Proposed Mixed Use Project

Urban Neighborhood Residential + Commercial on Greenwood Avenue

GREENWOOD PLACE
14307 Greenwood Avenue North

Response to Early Design Guidance Review Comments

PLANTING PLAN - LEVEL THREE AND FOUR

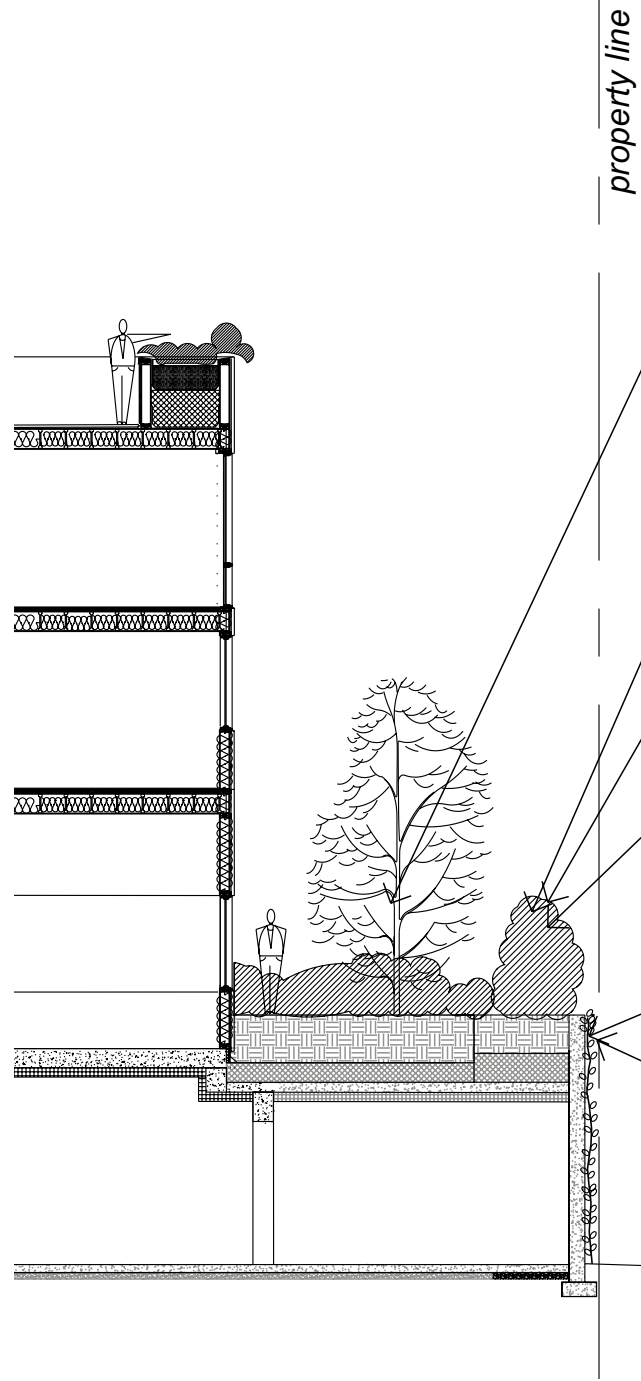
E-2 Landscaping to enhance the Building and/or Site. Landscaping, including living plant material, special pavements, trellises, screen walls, planters, site furniture and similar features should be appropriately incorporated into the design to enhance the project.	The applicant did not provide a landscape plan for the board's review. A detailed plan with the designation of plant species is required. The screen for the vegetation along the west property line should be shown in cross section to help clarify the relationship of the planting wall to the property line and how it will be maintained.	The appendix of this submittal includes a landscape plan for the board's review. A detailed plan was in place at the previous Board meeting but was inadvertently omitted from the initial Design Recommendation Package. The screen for the vegetation along the west property line has been added to the Landscape drawings in the appendix. Access for maintenance will be through an mutual agreement between the developer and the adjacent neighbor.

- MULTIPLE SPECIES TYPES
- FLOWERING EVERGREEN
- MAINTAINED BY AGREEMENT WITH NEIGHBOR
- REPLACED 9 FOOT TALL ROCKERY
- REPLACES UNCONTROLLED IVY VINES

- COATED WIRE GRID
- GALVANIZED STADOFF ATTACHEMENTS
- MINIMAL SURFACE AREA AT GRADE
- VINES WILL ALSO GROW FROM PLATER ABOVE

D-9 COMMERCIAL SIGNAGE

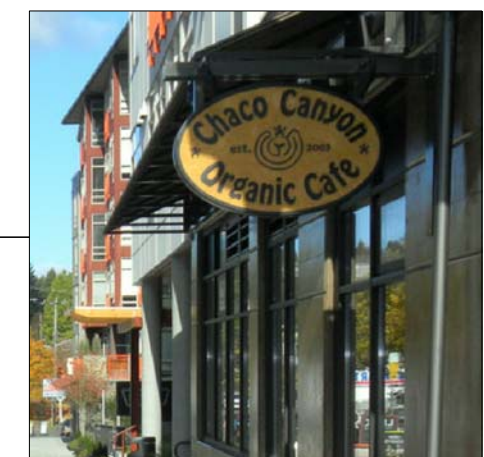
D-9 Commercial Signage. Signs should add interest to the street front environment and should be appropriate for the scale and character desired in the area.	Provide a signage concept plan for the next Recommendation meeting illustrating the type and location of commercial signage. Include building signage as well.	A signage diagram illustrating general location and design style has been added in the appendix of this package. The developer is not planning to have a general building sign. Addressing will be cast numeric characters, wall mounted adjacent to entry doors.

TO BE TWO SIDED, "BLADE" STYLE DESIGNS SUPPORT BELOW THE SECOND FLOOR BUILDING OVERHANG. SIGNS WILL NOT EXCEED 8 SQUARE FEET. SIGNS MAY BE ILLUMINATED BY NEON STRIP LIGHTS.

West Elevation

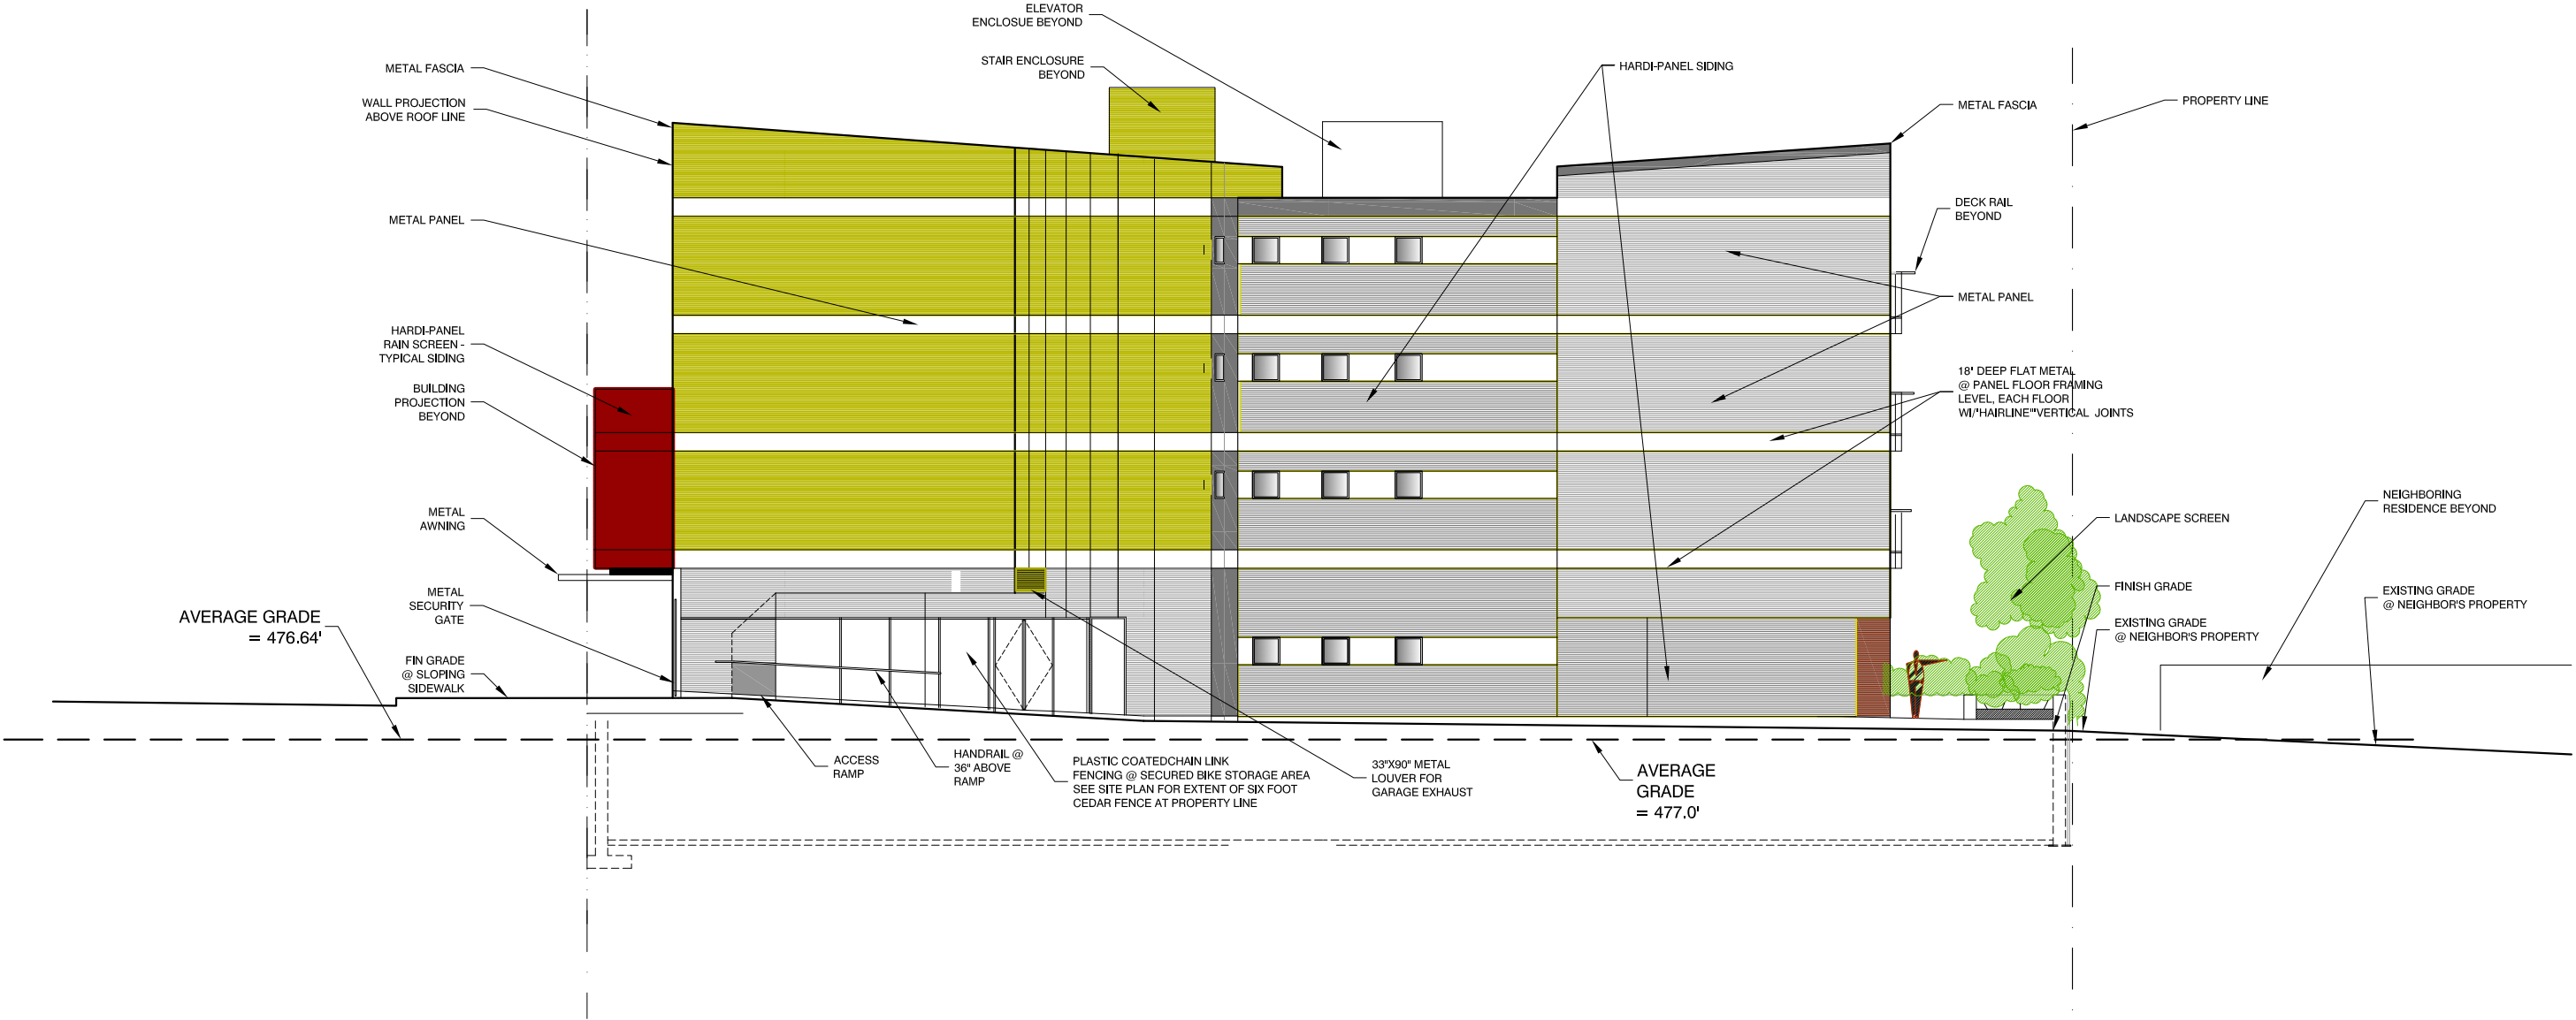
B-1 Height, Bulk and Scale Compatibility
Projects should be compatible with the scale of development anticipated by the applicable Land Use Policies for the surrounding area and should be sited and designed to provide a sensitive transition to nearby, less intensive zones. Projects on zone edges should be developed in a manner that creates a step in perceived height, bulk and scale between anticipated development potential of the adjacent zones.

The Board acknowledged the reduction in building scale at the property's southwest corner in response to the transition to a lower scale zone. The treatment of the proposed west facade will be scrutinized at the Recommendation meeting. See guidance A-5. The decks, fenestration and choice of materials should possess a residential scale compatible with the building's surroundings.

- The recommended deign proposes :
- stepping down of the southwest corner massing for roof terrace
 - the west facade has been substantially modulated with decks, built-in guardrail screens and view privacy "fin" walls
 - the landscaping within the building setback on the west side has been expanded and devised to provide a scale break up for the new building
 - the existing nine foot tall rockery will be replaced with climbing vines over the exposed basement wall that will form a a greenwall edge to the adjacent property
 - fenestration on the west facade will be smaller or deeply setback at deck
 - windows will be more residential in character and scale than elsewhere in the building.
